From: [Roland Lebrun](#)
To: [Murphy, Seamus](#)
Cc: [Board \(@caltrain.com\)](#); [VTA Board Secretary](#); [SFCTA Board Secretary](#); [Steve Heminger](#); [MTC Commission](#); [cacsecretary \(@caltrain.com\)](#); [Caltrain, Bac \(@caltrain.com\)](#); [SFCTA CAC](#)
Subject: Caltrain EMU specification
Date: Wednesday, April 06, 2016 1:21:40 PM
Attachments: [Alternate Caltrain EMU specification proposal.pdf](#)
[Caltrain seat & bike capacity.xlsx](#)
[Caltrain July 2105 Board Item #9 EMU procurement.pdf](#)

Alternate Caltrain EMU specification proposal

Upper deck modifications

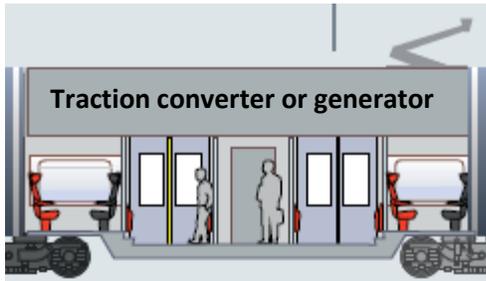
- Remove front stairs to upper deck
- 2+2 seating
- Remove luggage rack
- Remove tables
